STATE OF NORTH CAROLINA
DEPARTMENT OF TRANSPORTATION

Subject: **Application Update for an Individual Section 404 and Section 401 Water Quality Certification** for SR 1001 (Connelly Springs Road) from US 321A (Norwood Street) to SR 1712 (Starcross Road) in Caldwell County. Federal Aid Project No. MA-STP-7533(2), Division 11, WBS 34783.1.1, TIP No. U-2211B.

Please see the enclosed Revised Ecosystem Enhancement Program (EEP) mitigation acceptance letter and revised permit drawings for the above referenced project. The enclosed permit drawings replace permit drawings 3, 5, 6, 7 and 8 of 14 from the August application, and include an additional drawing, Sheet 14a of 14. Roadway design plan sheets 6 and 7 are also enclosed.

Revised
 Permit Drawing
 Sheet 7 of 14

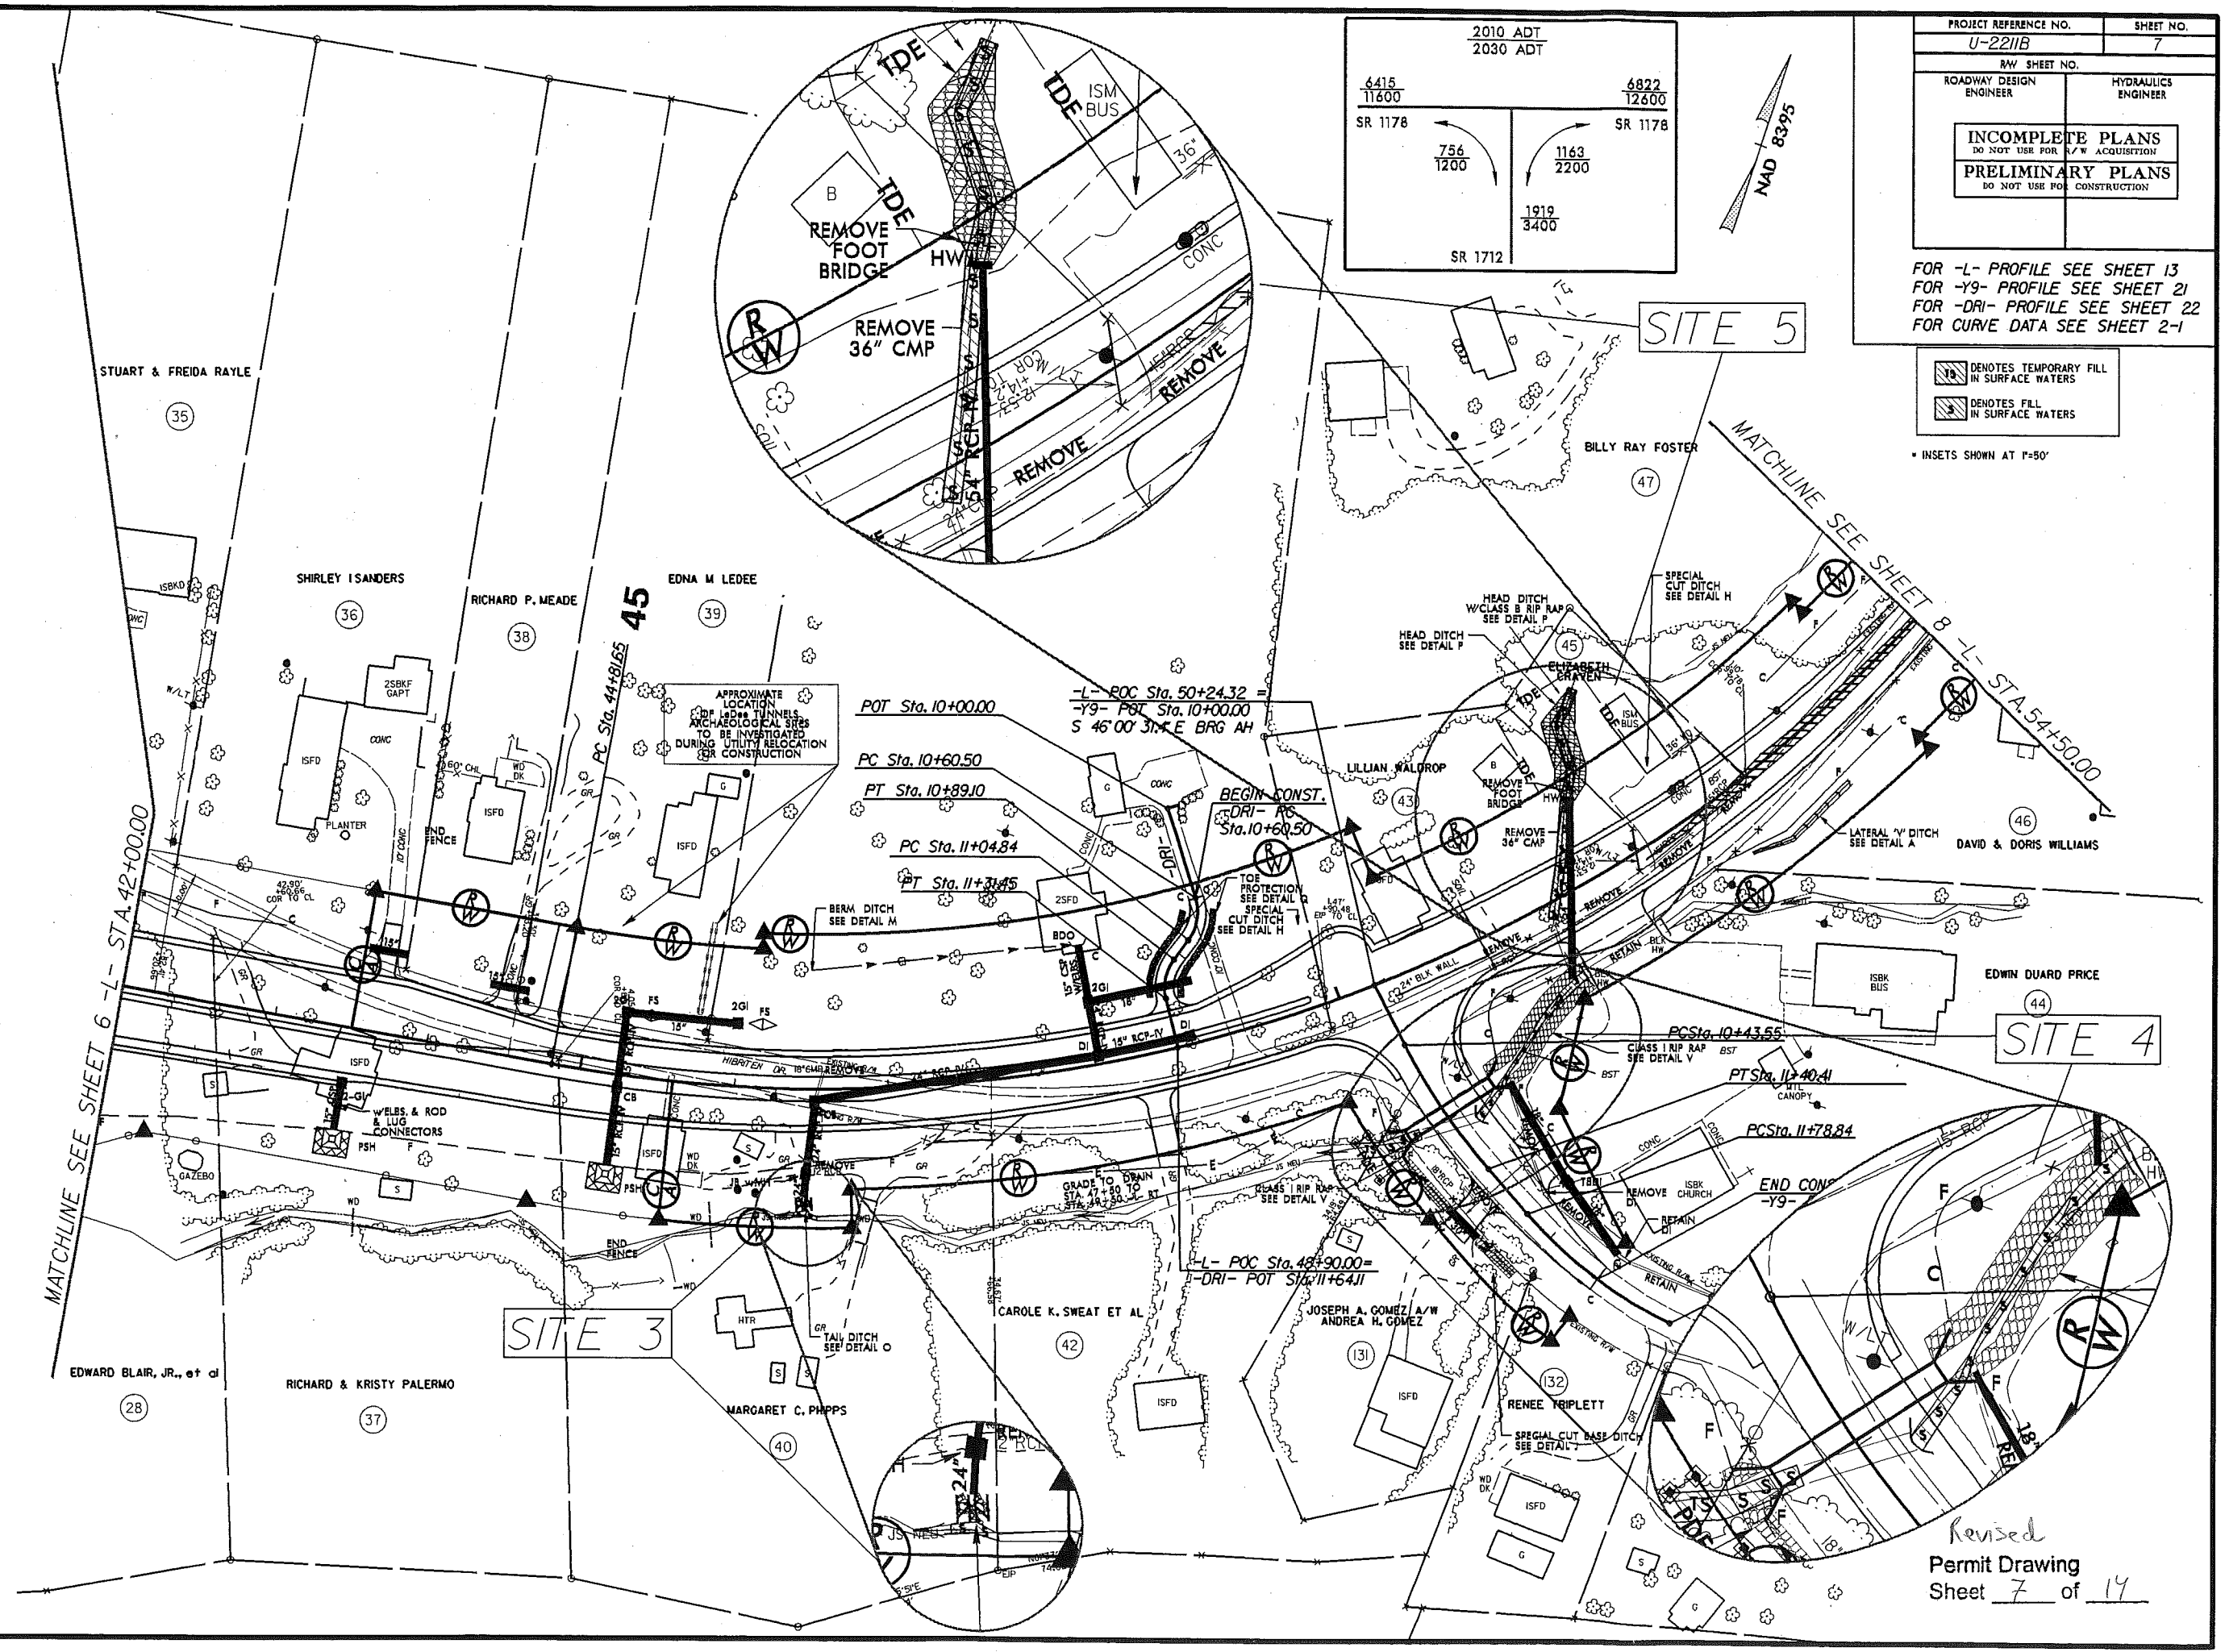
Permit Site 4: The existing 72" CMP, approximately 40' in length, that carries UT1 under Starcross Road (SR 1712) will be replaced with an 8' x 8' reinforced concrete box culvert (RCBC). This RCBC will be slightly longer (64'3") to accommodate the widened portion of Starcross Road, but will provide better alignment for the stream than the existing CMP. The pipe replacement will result in 42 linear feet of permanent impacts to UT1. Additionally, there will be <0.01 acre (19 linear feet) of temporary impacts associated with culvert installation and 41 linear feet of bank stabilization impacts to UT1 at the inlet and outlet ends of the new culvert. Previously, the temporary impacts totaled 29 linear feet (<0.01 acre), but 10 of these feet are now incorporated into the bank stabilization impacts described below.

A short section of UT1 between the inlet of the proposed culvert extension and the outlet of a pipe under a nearby driveway will now be stabilized and counted as a bank stabilization impact. This will result in 61 additional feet of bank stabilization impacts to UT1 for a total of 102 linear feet of bank stabilization at Site 4.

Permit Site 5: The existing 24" CMP, approximately 36' in length, that carries UT2 under Hibriten Drive will be removed and replaced with a 54" RCP to accommodate the widened roadway in this location. A portion of the channel on the inlet side of the new pipe will be lined with rip rap for stabilization purposes. This pipe replacement and upstream rip rap will result in 153 linear feet of permanent impacts to UT2.

The previous <0.01 acre of temporary impact listed for this site at the outlet end of the pipe is now incorporated into the bank stabilization impacts at site 4.
